# 44471A-01A <u>S E R V I C E N O T E</u>

Supersedes: 44471A-01

## Defective connectors shipped with 44470A, 44471A, 44473A, 44474A

Figure 2: Good Connector with alternating pins on top and bottom

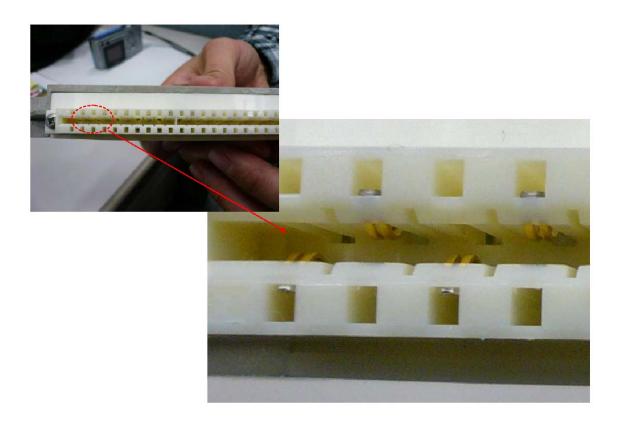
The 44470A, 44471A, 44473A, and 44474A products consist of a main relay plug in module and a removable terminal block (see Figure 1). These are plug in modules for the card cage mainframes 3488A, 3499A, 3499B, and 3499C. The main relay card contains the serial number. The removable terminal module does not contain a serial number. It is possible that over time a terminal block will no longer be used with the same serialized relay card that it was shipped with A visual inspection of the connector in the removable terminal block is necessary to determine if a defective connector is present. The visual inspection should override the serial number range limits. All white colored connectors are good and have pins that alternate top to bottom (see Figure 2). A black colored connector is bad if it contains all pins on one side of the connector (see Figure 3). A black colored connector is good if it contain pins that alternate top to bottom (not pictured).

Figure 3: Defective Connector with all pins on one side

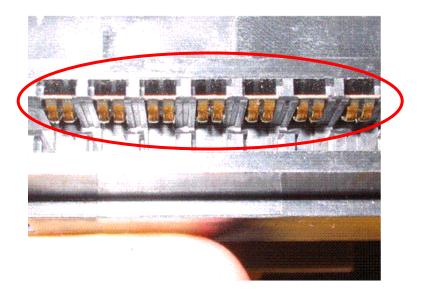
The 44470A, 44471A, 44473A, and 44474A contain a main relay card and a removable screw terminal block (see Figure 1). Some of the removable terminal blocks that were shipped between 1-Jan-2008 and 08-April-2008 have a defective connector that results in half of the pins being unconnected.

The procedure to correct the defective connectors is very simple. One must replace the defective connector with a good connector (see connector part numbers list one page 2). The customer may perform this procedure or have an Agilent-qualified person perform this procedure.

Figure 4: Removing defective connector from terminal block

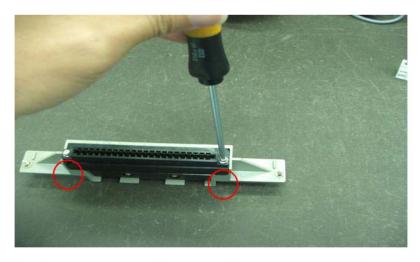
**Connector Replacement Procedure**: After identifying a defective connector, the connector in the terminal block is repaired by removing the two screws that hold the connector to its case. Note the orientation of the connector. This will release the connector from the terminal block and then a good one can replace it. No soldering is necessary. See Figure 4.

1. Use a T10 torx driver to unscrew the 2 screws of the connector.

Use the same torx driver to screw on the good connector, using the same orientation at the connector you just removed (see Figure 5).
